66309B-08

S E R V I C E N O T E

66309B - MOBILE COMMUNICATION DC SOURCE, DUAL-OUTPUT 15V/3A,12V/1.5A. GPIB

Power-On Self test Errors, Auto reboot, Blank display. No output Communication errors. No communication when using the GPIB Interface.

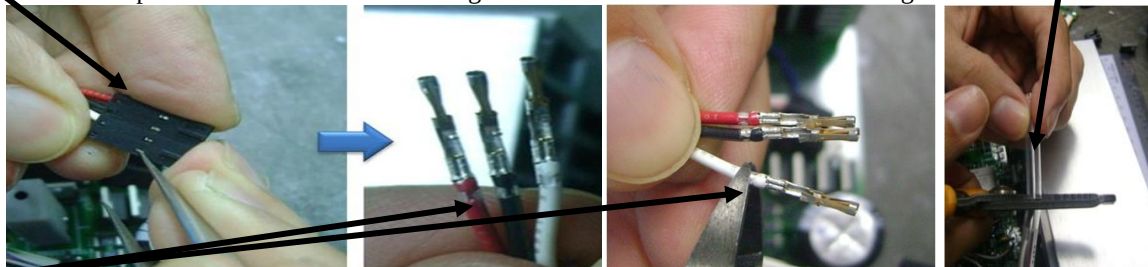
The cable P/N 5080-2452 coming from the control board should be disconnected for the mail connector (circuit reference) "J206" which is soldered on the interface board.

Remove the connector P/N 1252-3695 (circuit reference) "J206" on the "A2" interface assembly. When removing "J206" care should be taken not to damage the "A2" printed circuit board material or the circuit board traces. "J206" has 4 holes remove the solder from these holes as shown. Do not apply too much heat or pressure this may cause damage to the PCA

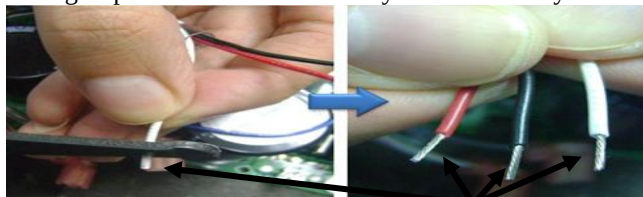
Remove the pins from the connector housing as shown. Cut 3cm off the clear tubing of the cable

Cut the crimped terminals at the crimp around the wires colored insulation. This is done so the cable length can be as long as possible a short cable may cause assembly issues.

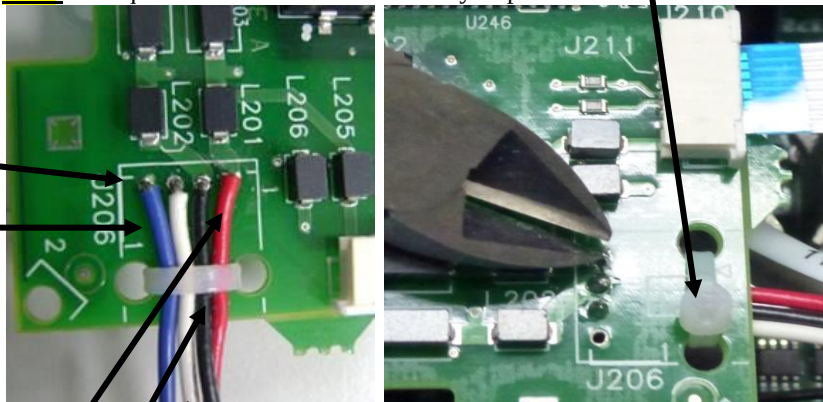
Insert the cable into the open holes located on the “A2” GPIB interface assembly.

Depending on the model there may be three or four wires.

The **Red** wire is soldered in the main control board (reference E320) and should be soldered into pin #1 or the square pad of “J206” on the “A2” interface assembly.

The **Black** wire is soldered in the main control board (reference E324) wire should be soldered into pin #2 of “J206” on the “A2” interface assembly. .

The White wire is soldered in the main control board (reference E321) should be soldered into pin #3 of “J206” on the “A2” interface assembly.

The **Blue** wire is required for the models shown below **ONLY**. This **Blue** wire comes from the connector on the battery emulation board P/N 5064-0131 circuit reference J001 Pin 12, the **Blue** should be soldered into pin # 4 of “J206” for the models listed below only. All other **66300X Mobile Comm DC Sources** only require 3 wires.
